10.0 Steam and Power Conversion System

The information in this section of the reference ABWR DCD, including all subsections, tables and figures, is incorporated by reference with the following departures and supplements.

Figure 10.1-1 Reference Steam and Power Conversion System

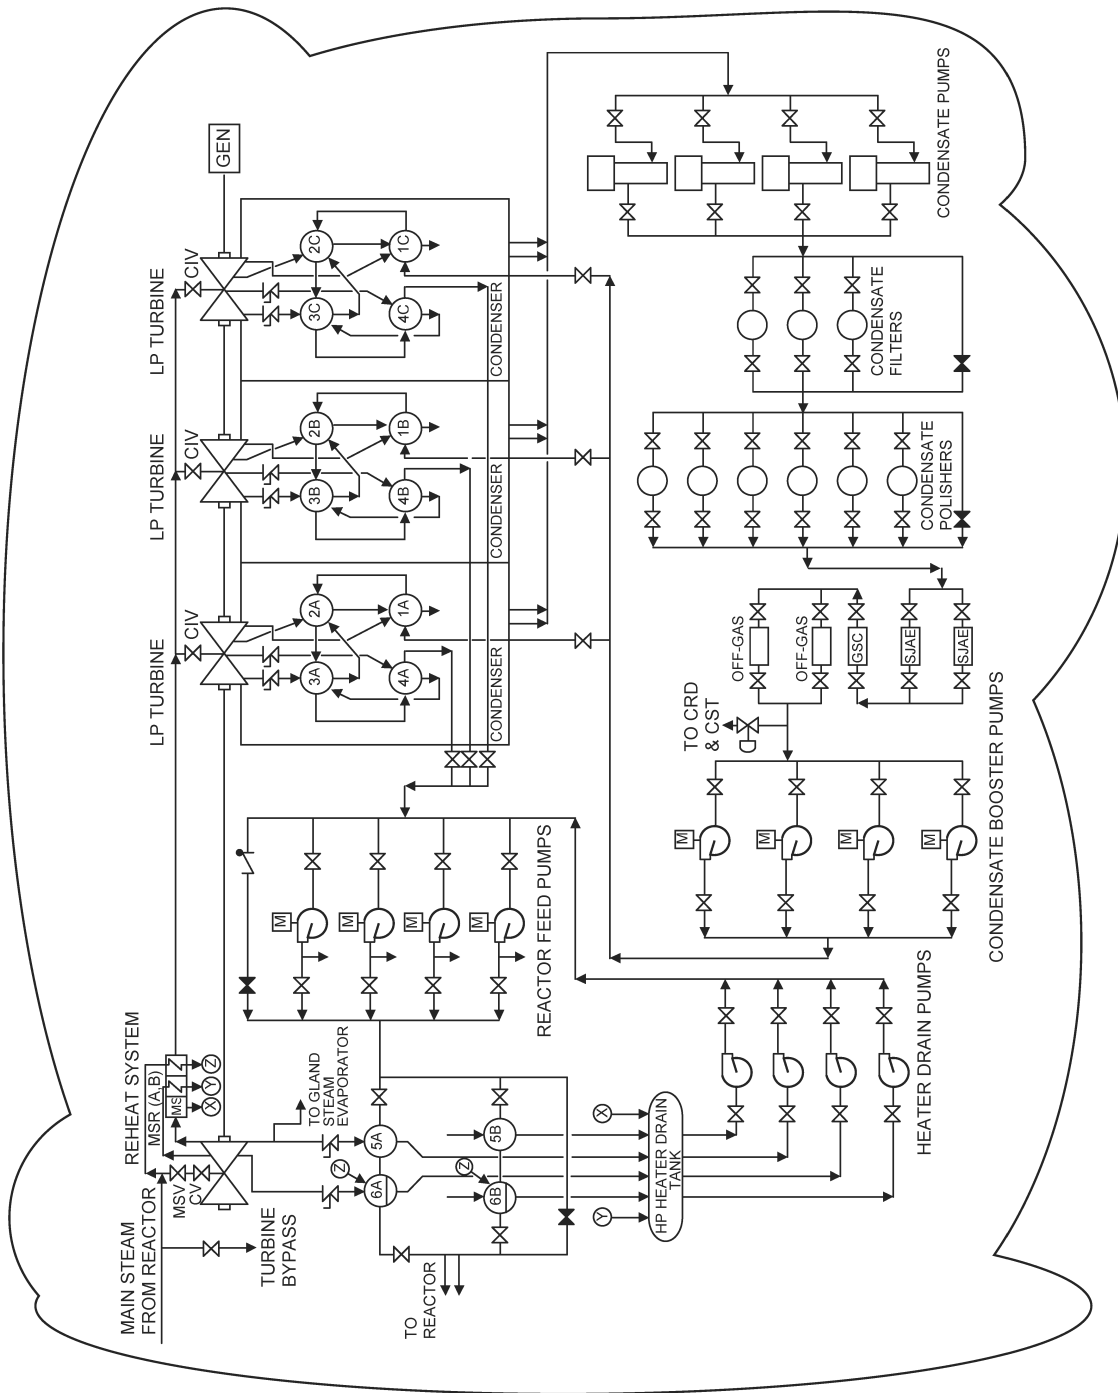
STP DEP 10.1-2 (Figure 10.1-1)
